PROJECT:	Gas Holder Site, Reading		
TITLE:	REVISED PARKING NUMBERS		
REVISION:	REV 2		
PREPARED BY:	Sarah Allen	Date:	14 November 2024
APPROVED BY:	Sarah Allen	Date:	14 November 2024
REVISION BY	Sarah Allen	Date	6 March 2025

Danescroft (KDPM) LLP
Gas Holder, Reading
Proposed Plan-Ground Floor-Opt 1

Proposed Plan-Ground Floor-Opt 1

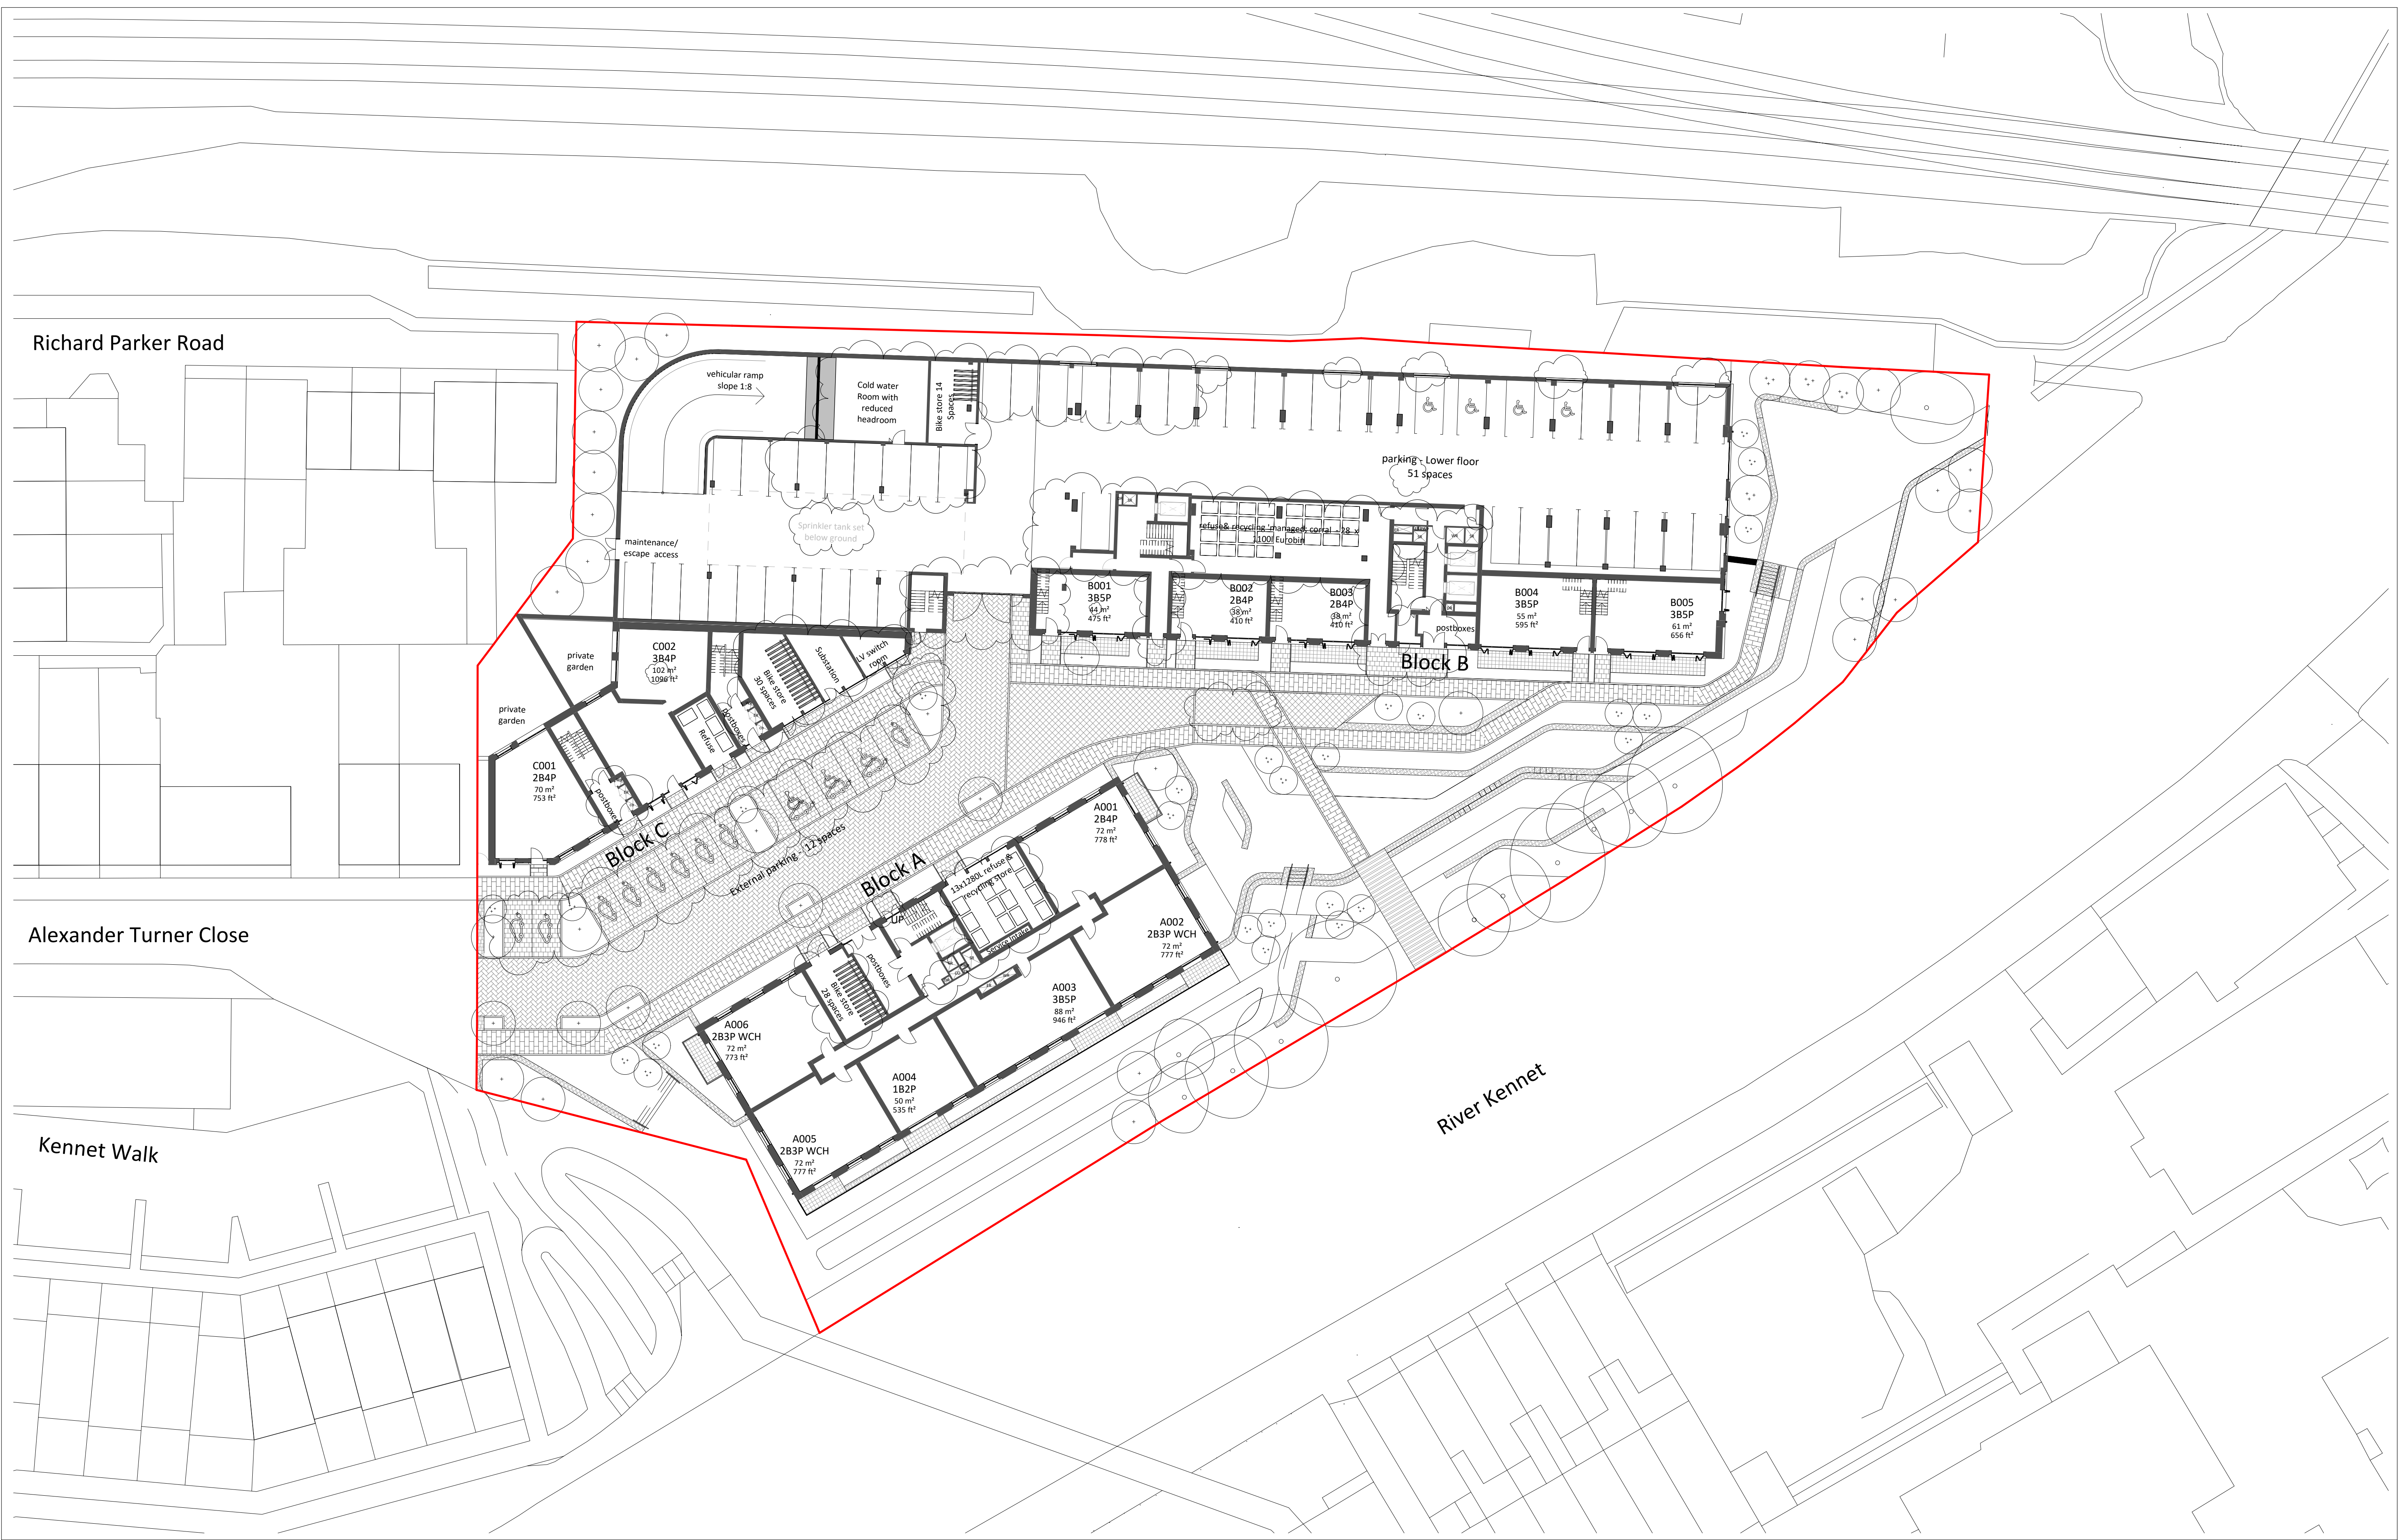
In order to accommodate the EV charging spaces on the main access road whilst maintaining good quality pedestrian routes and key landscape areas, the 4 parallel parking spaces located on the access road adjacent to Block B have been removed. This is shown in **Appendix 1- Collado Collins Architects' Drawing - Proposed Plan-Ground Floor-Opt 1**, attached.

Following the Fire & Life Safety study findings, the EV charging spaces were relocated to the surface parking areas along the access road. In order to accommodate this and maintain quality pedestrian routes and key landscape areas, the 4 parallel parking spaces adjacent to Block B were removed from the access road.
